RE: Response Letter - LU-22-209 635 Sagamore Ave, Portsmouth, NH Tax Map 222, Lot 19 JBE Project No. 18134.1

We are in receipt of comments from the Technical Advisory Committee, provided by Stefanie Casella, City Planner, dated March 29, 2024. Review comments are listed below with our responses in bold.

UTILITY PLAN

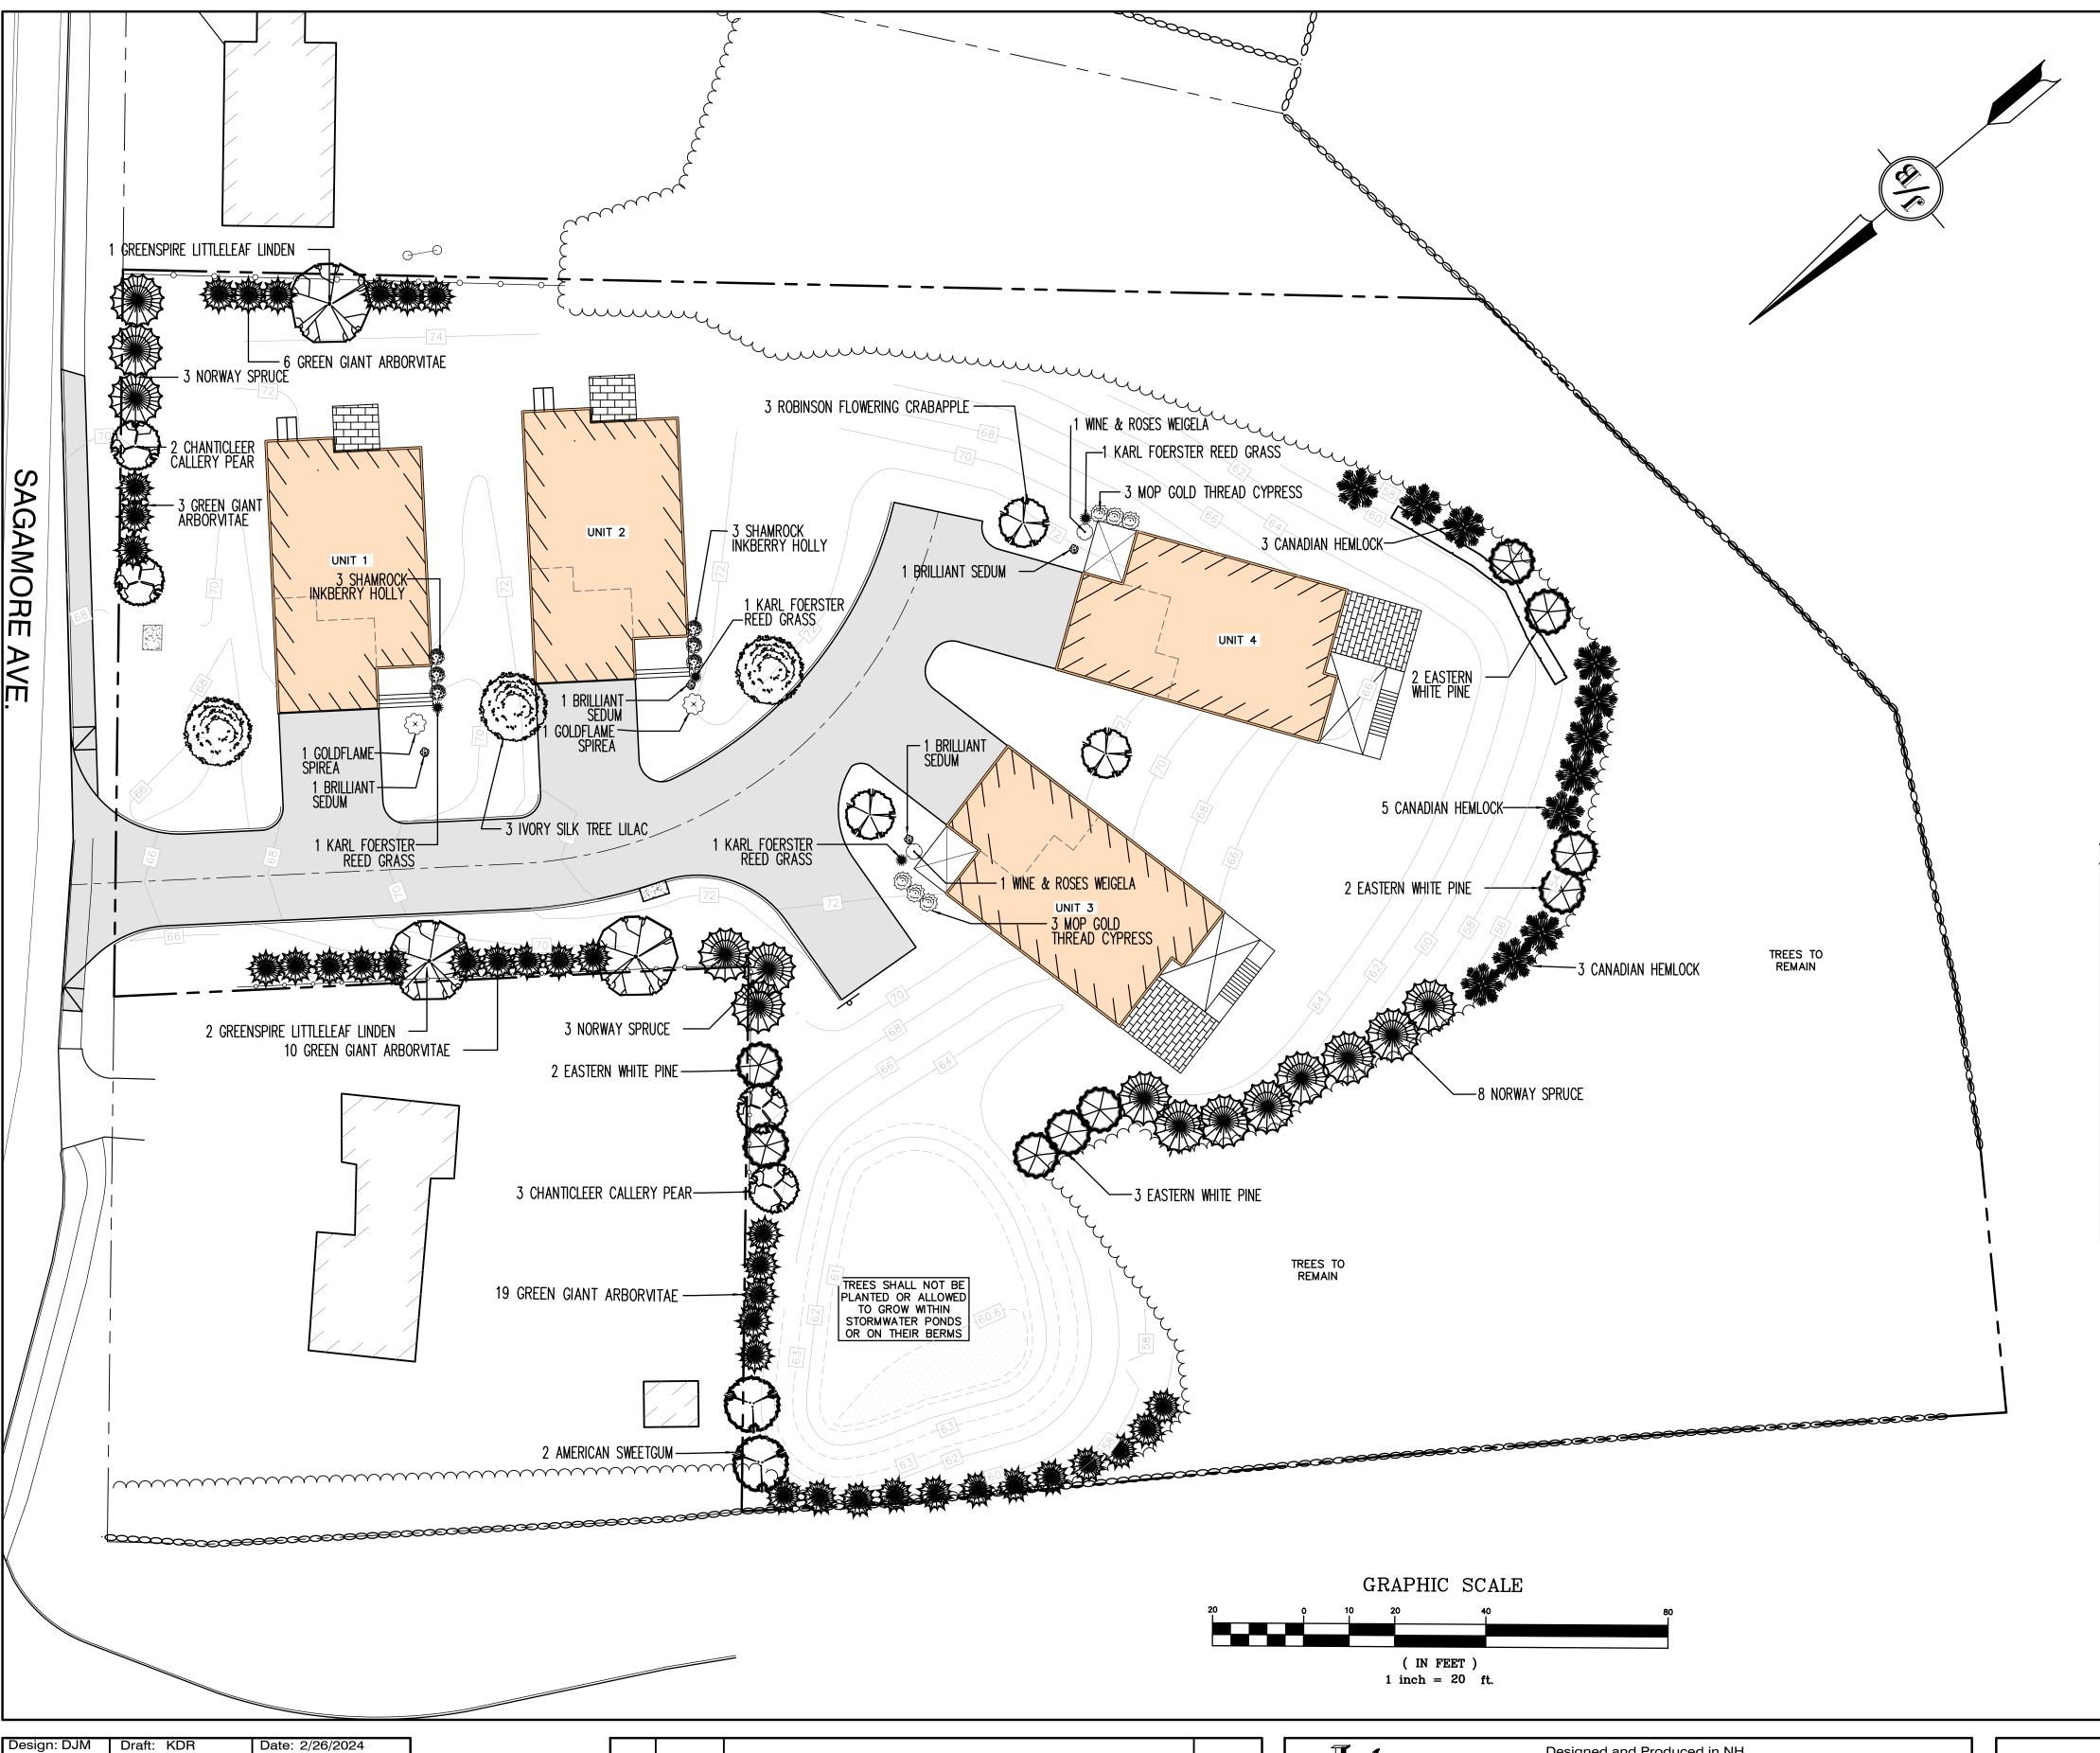
5. Remove label for 4" water main on far side of Sagamore Road. 4" water main has been abandoned.

6. Are there plans to extend gas to the site? Stub gas main label on overhead wires south of site. Sheet C4 Utility Plan.

RESPONSE: The word "Abandoned" has been added to the label for the 4" water main on Sheets C1 and C4.

RESPONSE: We are not planning to extend the gas main to the site. The units will have propane tanks as shown on Sheet C4. The "stub gas main" label was a holdover from when natural gas service was being considered and has been removed.

LANDSCAPE PLAN Plan Name:

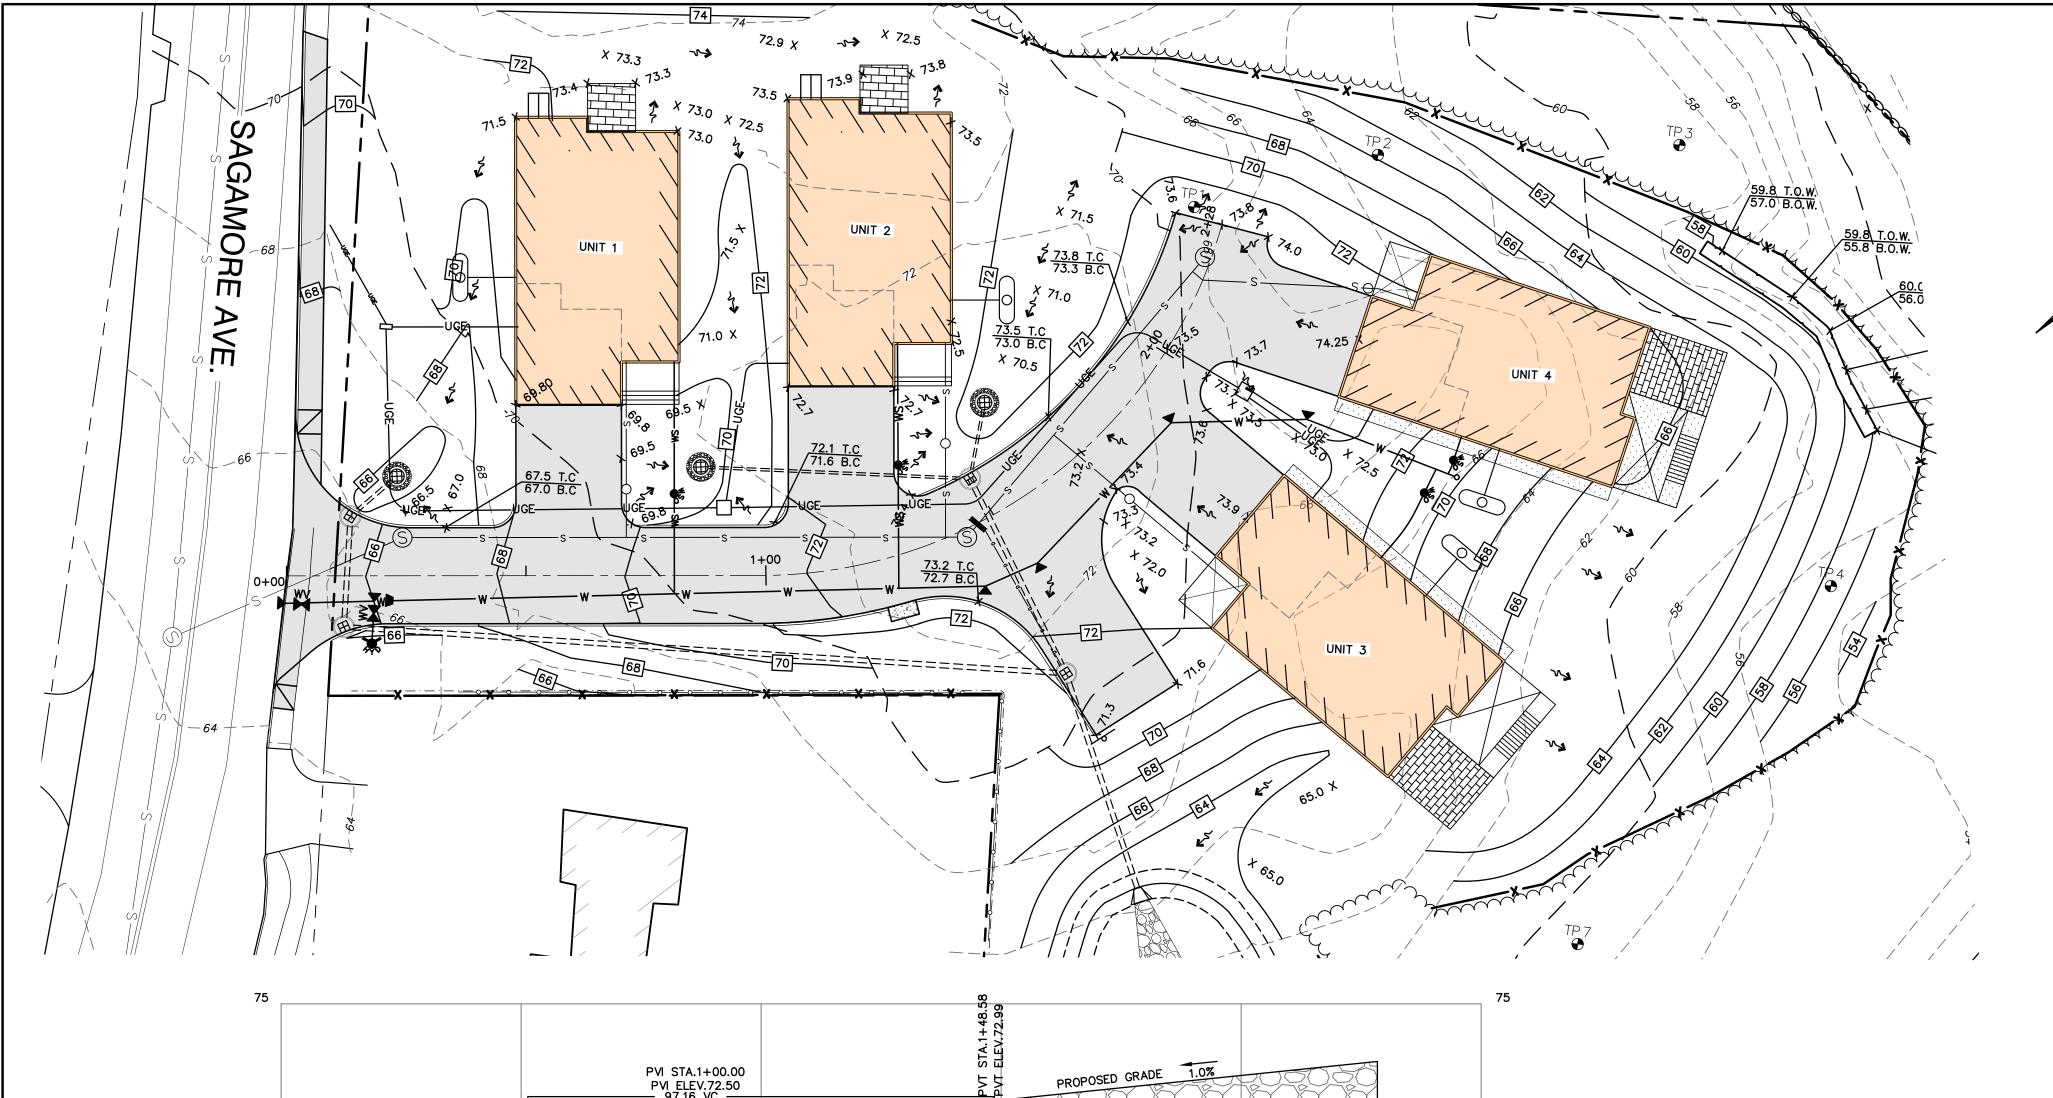
- 14. Please update landscaping plans to acknowledge planting requirements [Section 6.2.2 (d-f), and Section 6.4] and to demonstrate adherence to Section 6.3 in the Site Plan Review Regulations.

- RESPONSE: The landscape designer has denoted on the planting schedule on Sheet L2 which plants are tolerant of urban conditions and also added Notes 19 and 20 to this sheet stipulating the requirements that need to be followed.
